**Subject: 576 Riverside Drive
Replacement Wastewater Disposal System
Augusta, Maine**

Subject: Approval, Cooper Properties, Inc. Property, 576 Riverside Drive, Augusta

PROJECT
**576 RIVERSIDE DRIVE
 SUBSURFACE WASTEWATER SYSTEM**
 TITLE
REVISED SITE PLAN

EXHIBIT A

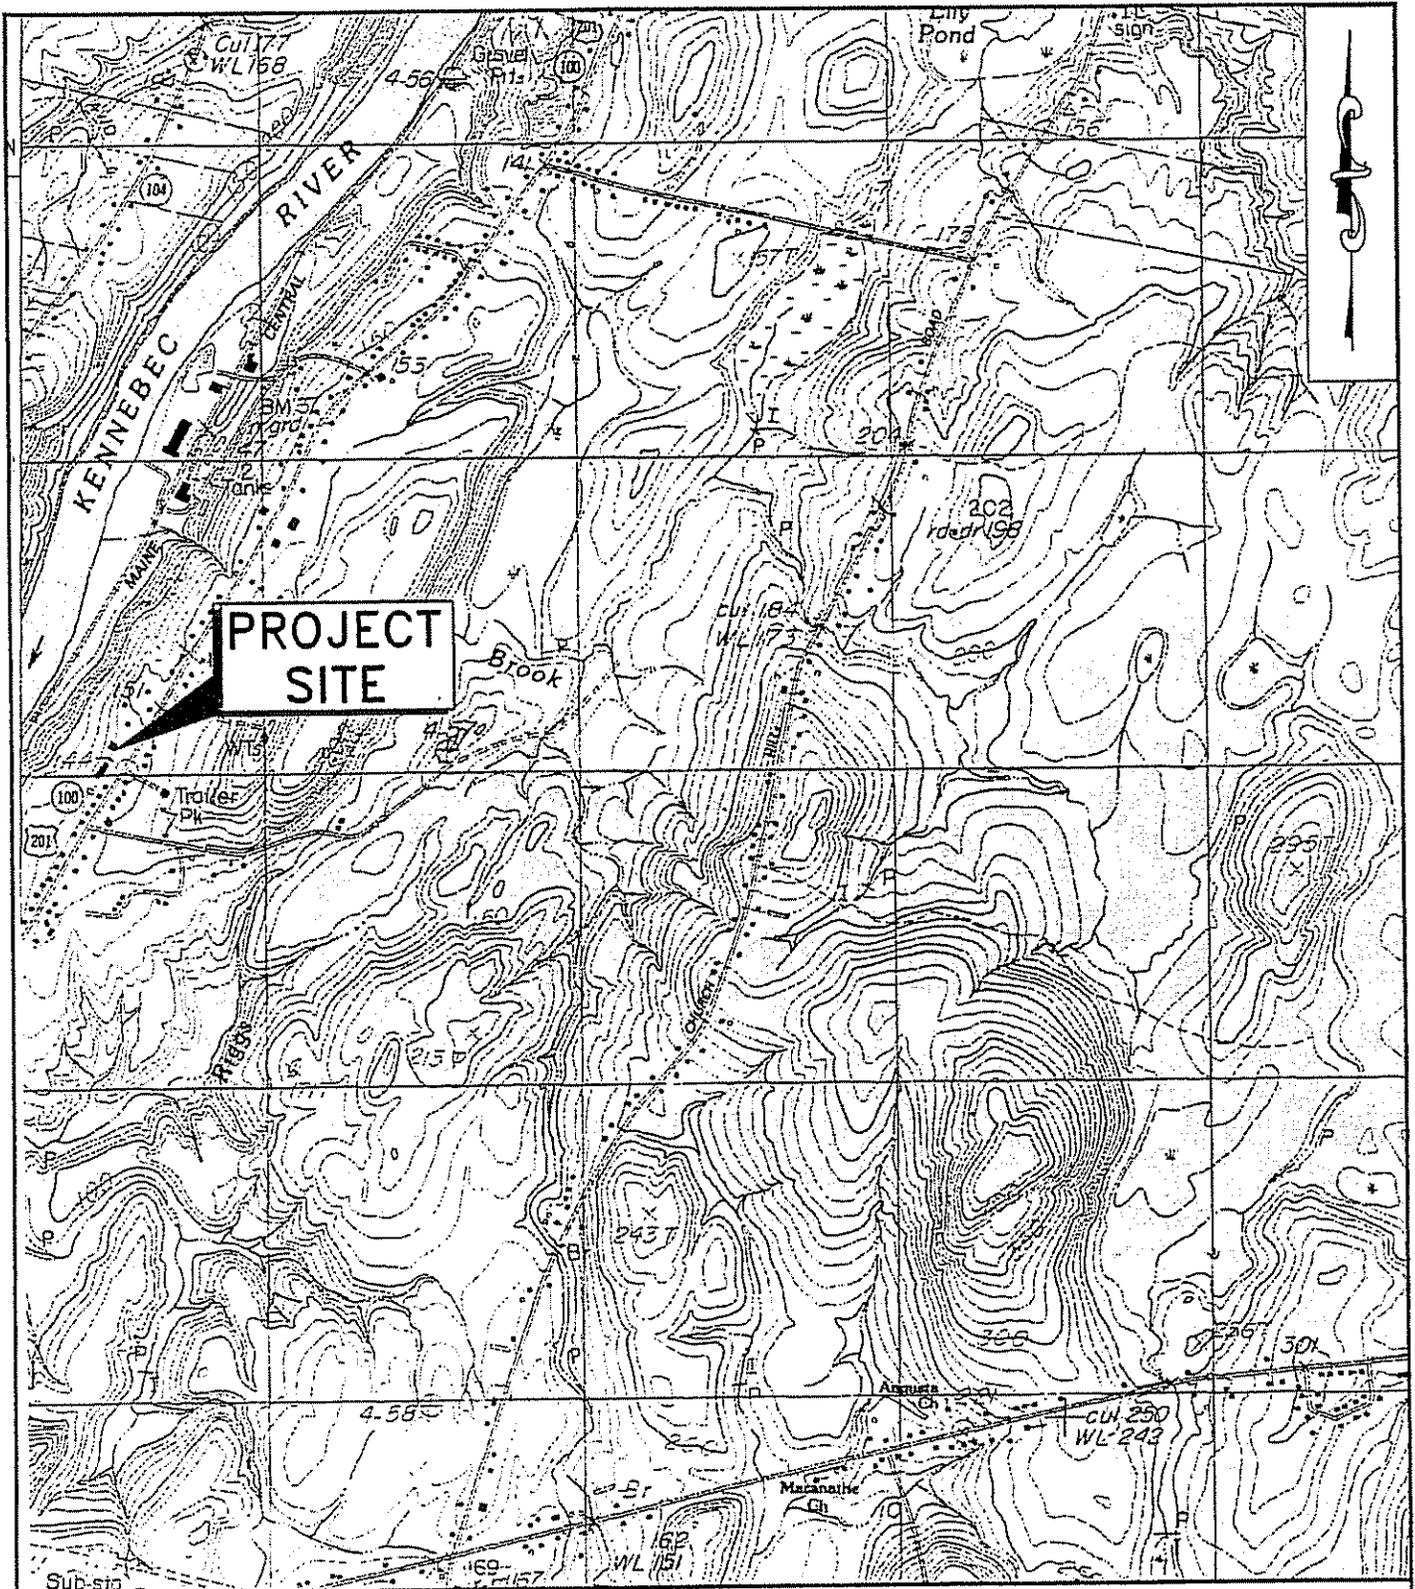
MDEP also provided the following specific comments: the 68.5 gpd/ft.² hydraulic conductivity (K) value used in the mounding analysis appears inappropriate, and ought to be in a range between 9.0 gpd/ft.² - 30 gpd/ft.² pursuant to N.R.C.S. values for Nicholville soils; and the site location is shown incorrectly on the USGS topographic map supplied.

The remaining conditions, 2 through 15, will be complied with as the project moves forward. Additionally, we have included revised and corrected copies of Exhibits A and E.

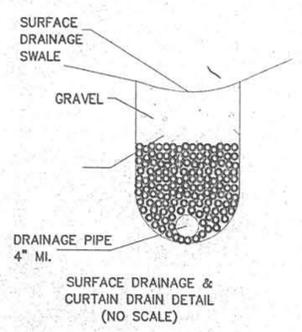
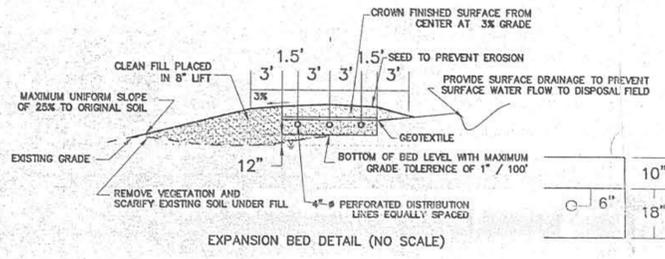
The plan lacks contour lines pursuant to Section 1102.6 of the Rules.

1. Prior to issuance of a permit by the Local Plumbing Inspector to install the proposed expansion, the design engineer shall:
 - A. Submit to the Division for review and approval a revised site plan with contour lines, and
 - B. Submit to the Division for review and approval either a revised site plan showing one additional 2,000 gallon septic tank and one additional 4,000 gallon septic tank; or a revised narrative description which includes one additional 6,000 gallon septic tank. The number of existing tanks shall also be verified, and
 - C. Submit to the Division for review and approval a revised page 1 of the HHE-200 Form with latitude and longitude conforming to Section 401.6.1 of the Rules, and

- 1.A. The revised site plan with contour lines.
- 1.B. The goal of adding additional septic tanks is to result in a total in-place volume of 12,000 gallons. The goal will be achieved by:
 - Existing built in place tank 6,000 gal.
 - First new commercial tank 4,000 gal.
 - Second new commercial tank 2,000 gal.

REV	DATE	STATUS	BY	CHKD	APPD
1	2-9-07	PROPOSED CONTOURS ADDED	ARA	CJM	SCD
